Carlyle/Eisenhower East Design Review Board (DRB) Application

PROJECT NAME: Carlyle Block P BLOCK: P

DESCRIBE THE REQUEST BRIEFLY: Approval to minor modifications to the previously approved design of the South Tower of Carlyle Block P.

765 JOHN CARLYLE - SOUTH TOWER

1 CONNECTOR CHANGES

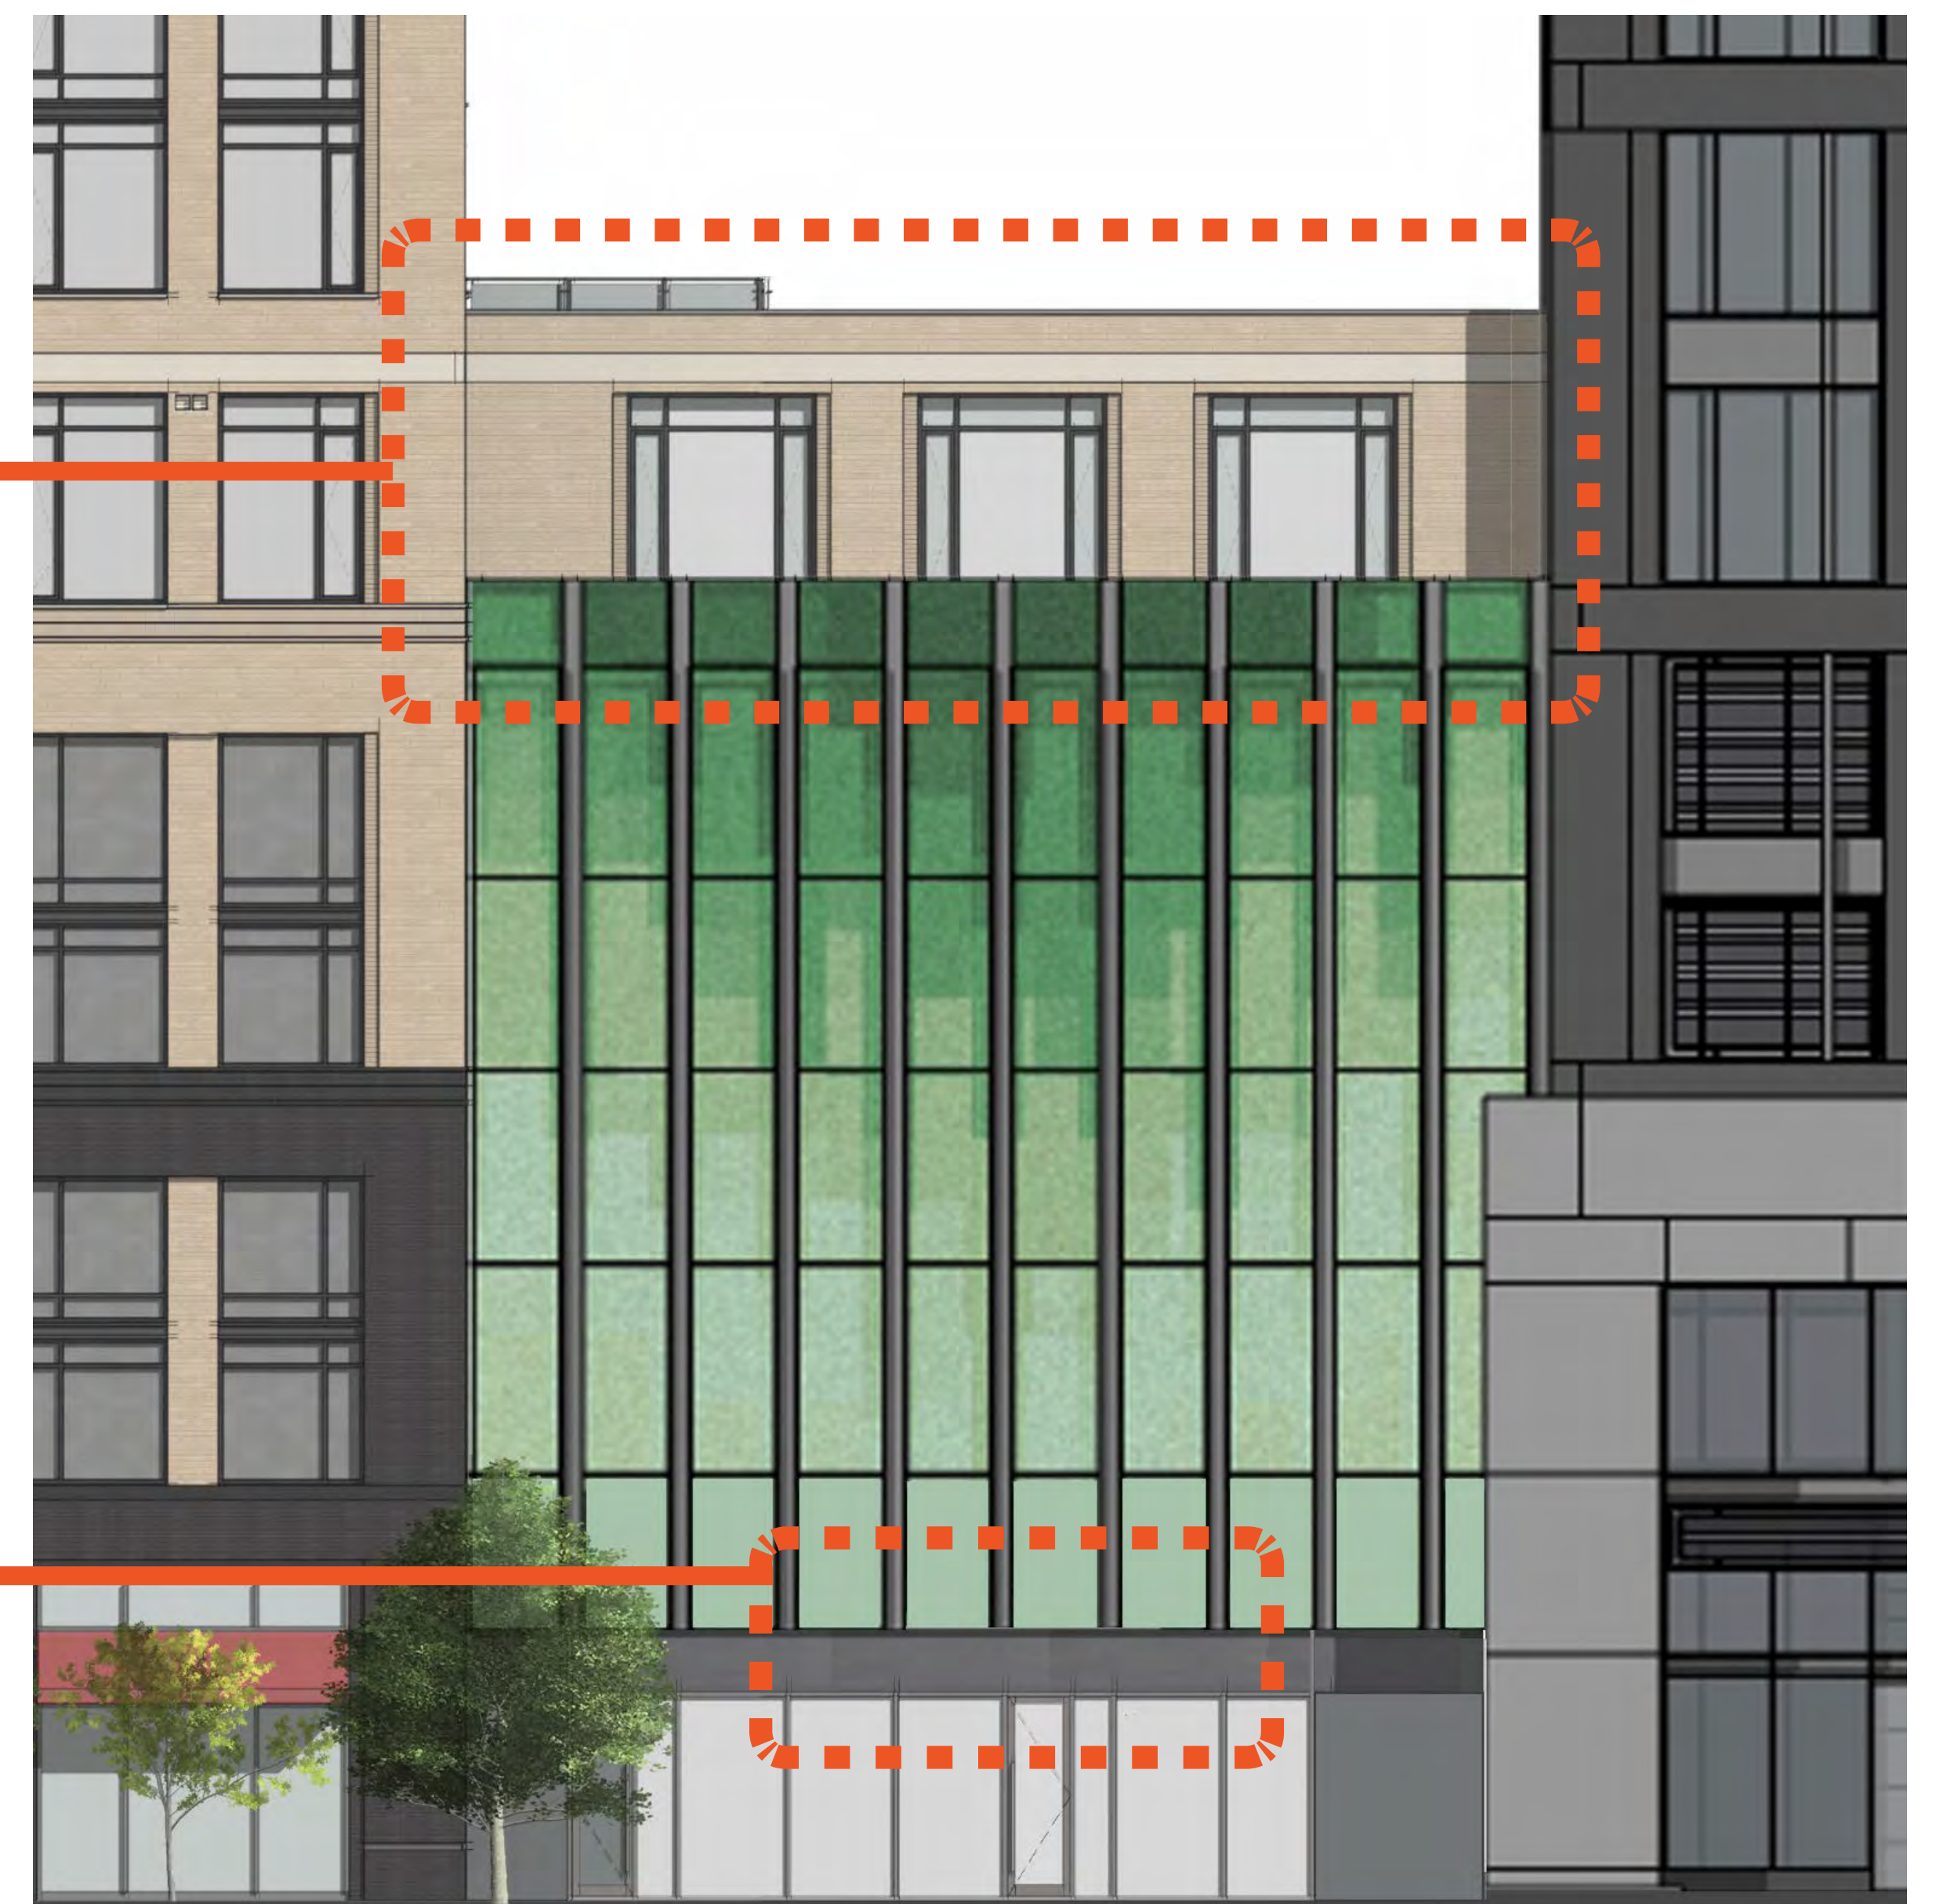
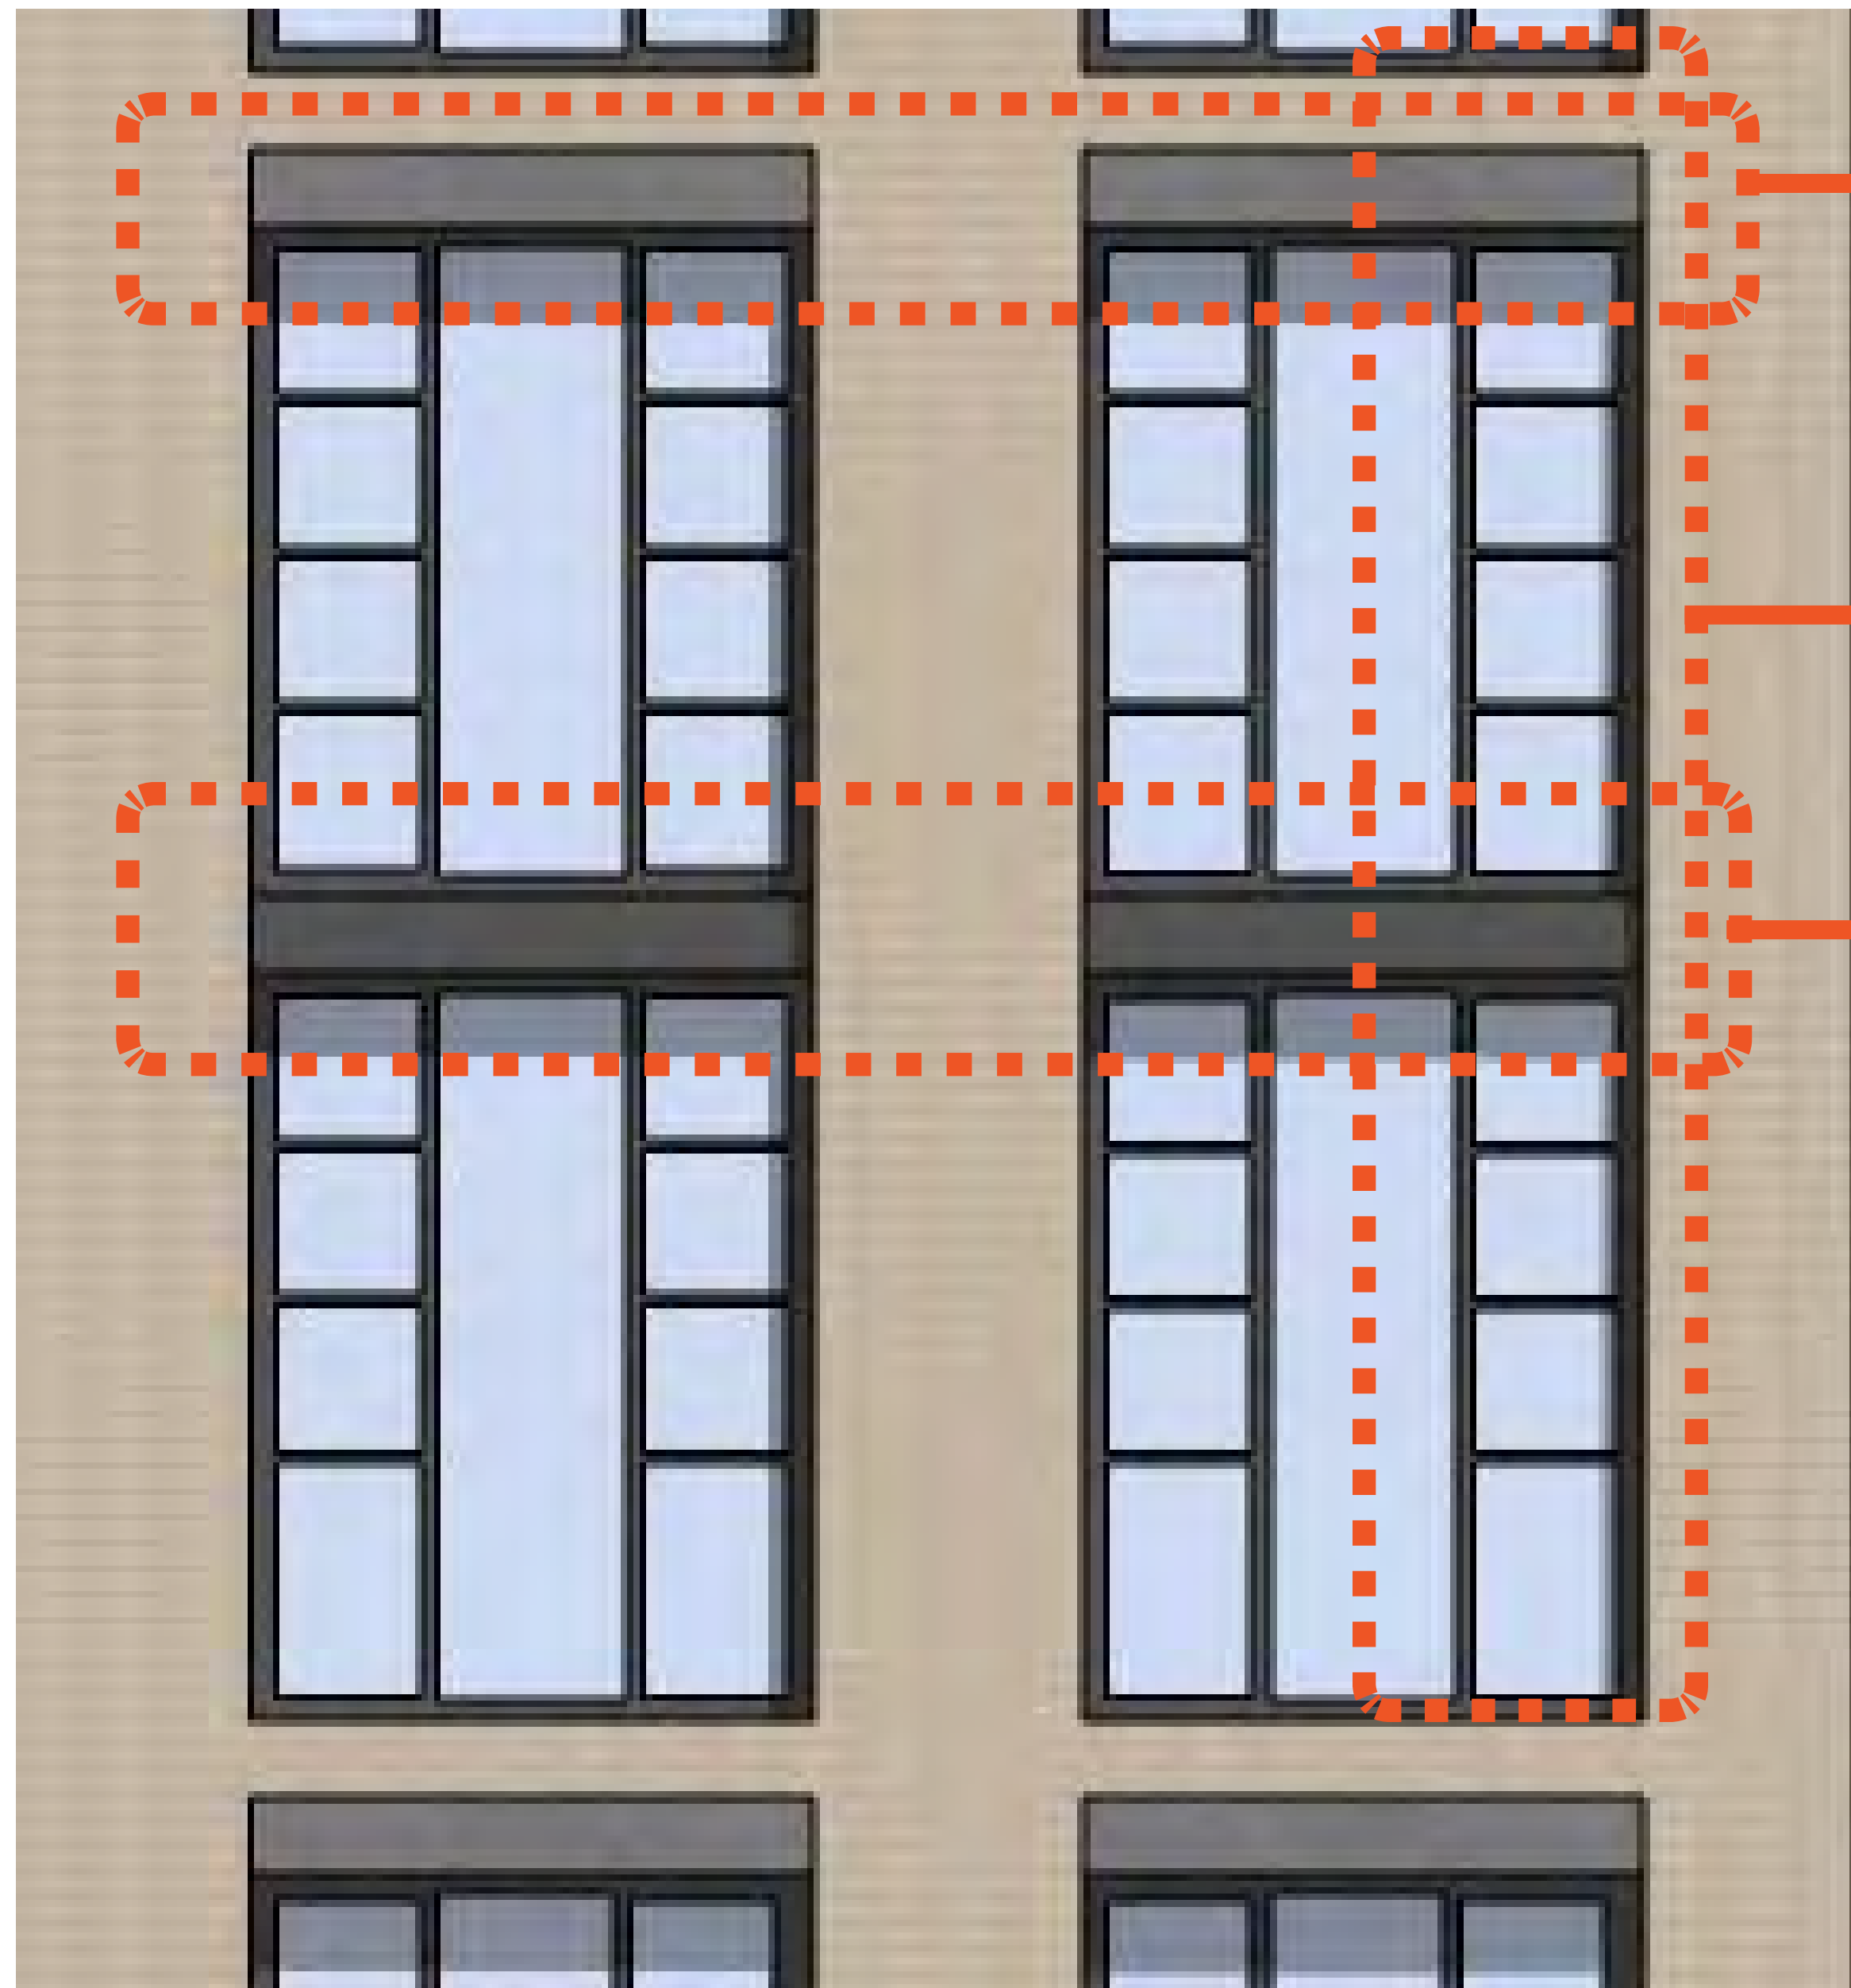
CHANGED FROM GLASS TO
GLASS AND LIGHT BRICK
AND RAISED PARAPET

REMOVED CANOPY
